Appl. No. 10/645,212  
Amdt. dated October 22, 2004  
Reply to Office Action of May 7, 2004

**Amendments to the Drawings:**

Figure 4

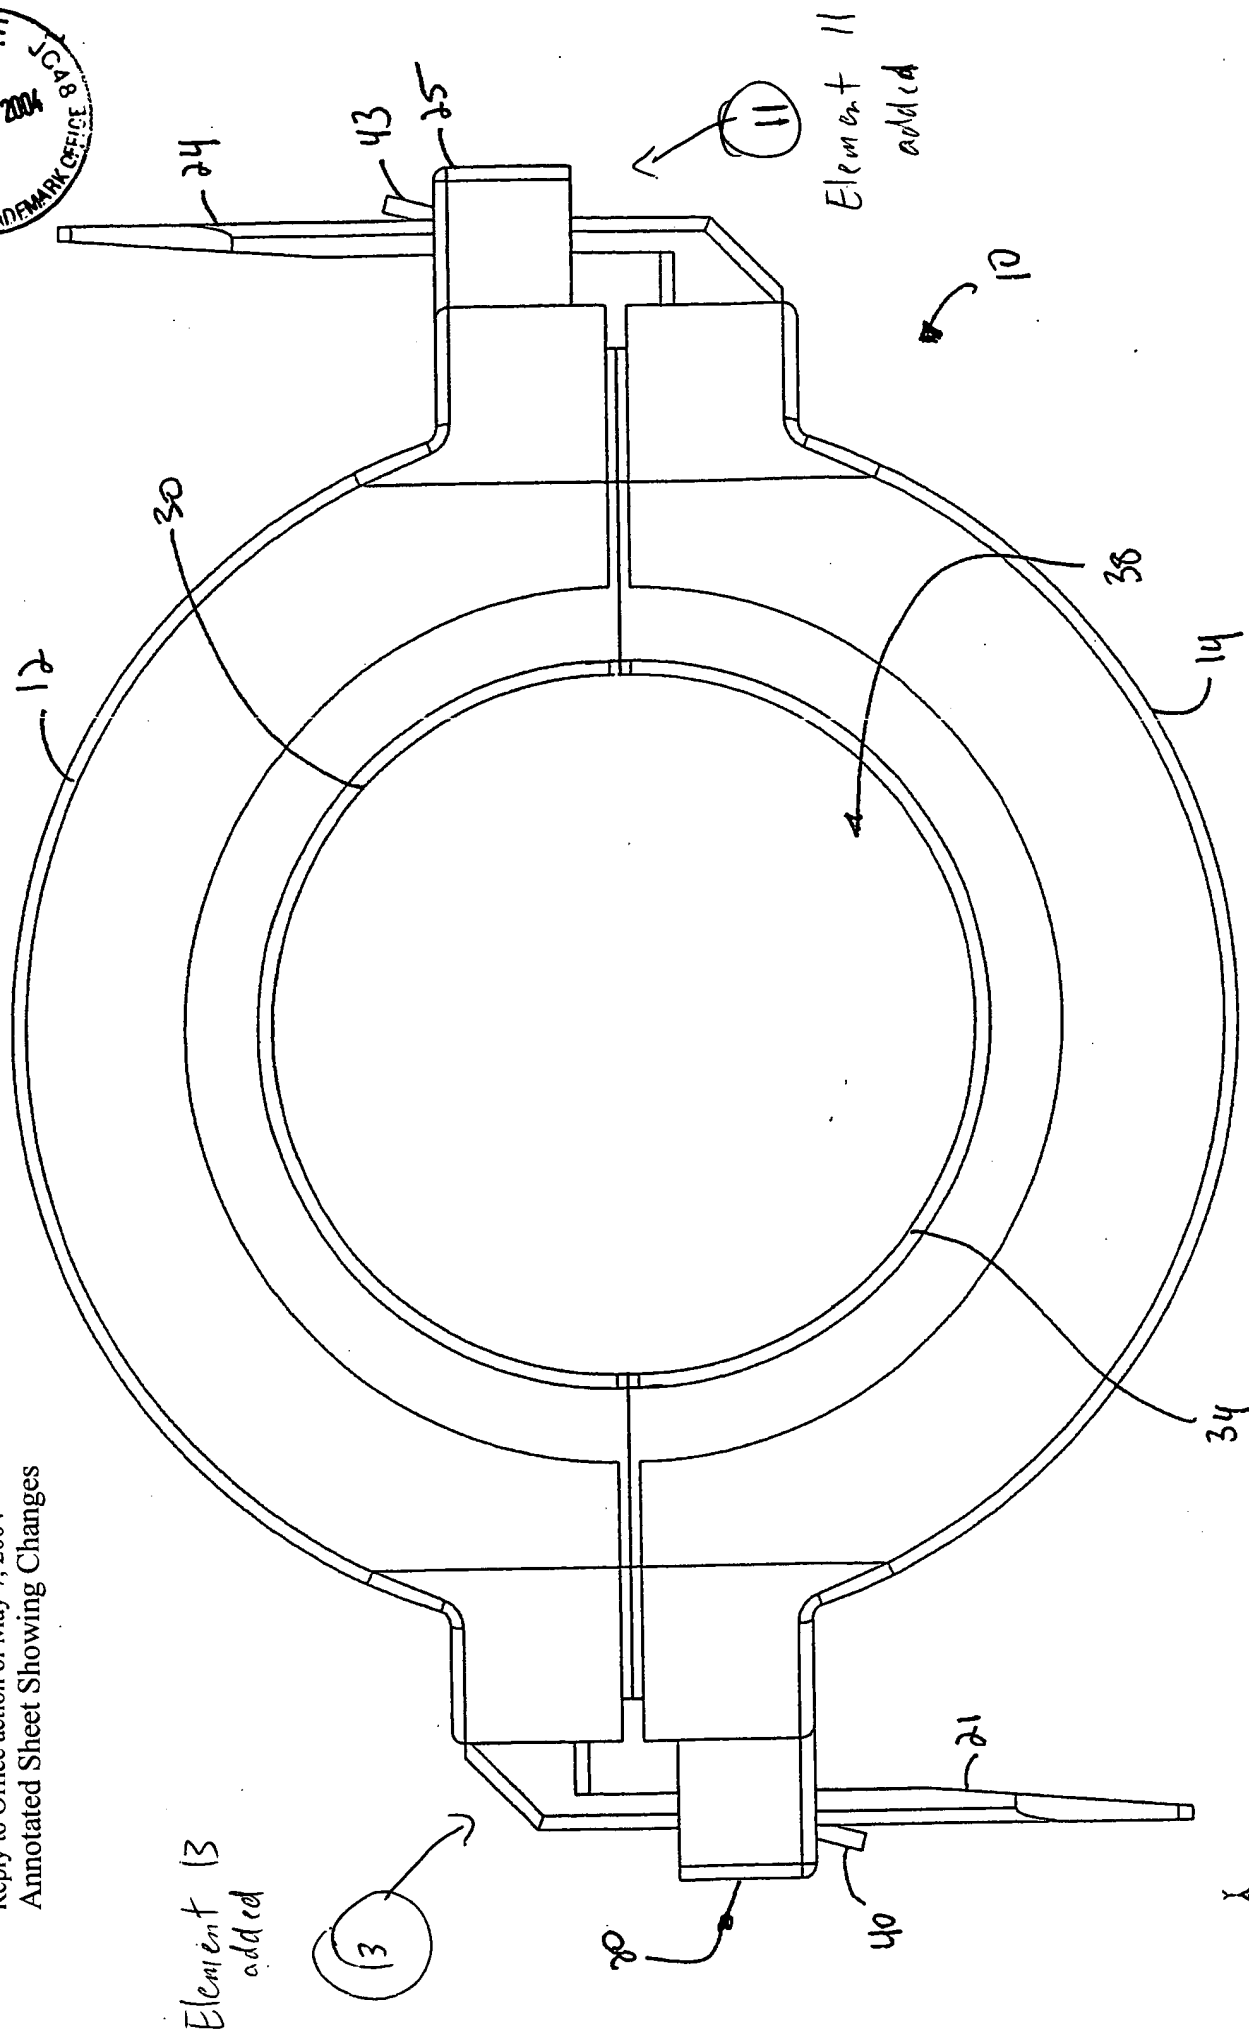
The attached sheets of drawings include changes to Figures 2 and 4. These sheets, which include Figures 2 and 4, replace the original sheets including Figures 2 and 4. In Figure 2, previously omitted element 11 has been added. In Figure 4, previously omitted elements 11 and 13 have been added.

In the drawings, Figures 2 and 4 have been amended to include a reference number for first and second connectors to address the Examiner's objections to the drawings regarding the lack of reference to first and second connectors. In the specification, paragraph [0011] has been amended to include the additional reference numbers in the amended drawings. Specifically, reference numbers 11 and 13, respectively, for first and second connectors have been added to the specification and Figures 2 and 4 of the drawings. Applicant respectfully submits that the above amendments address the Examiner's objections to the drawings regarding first and second connectors, and that the drawings are now in condition for allowance.
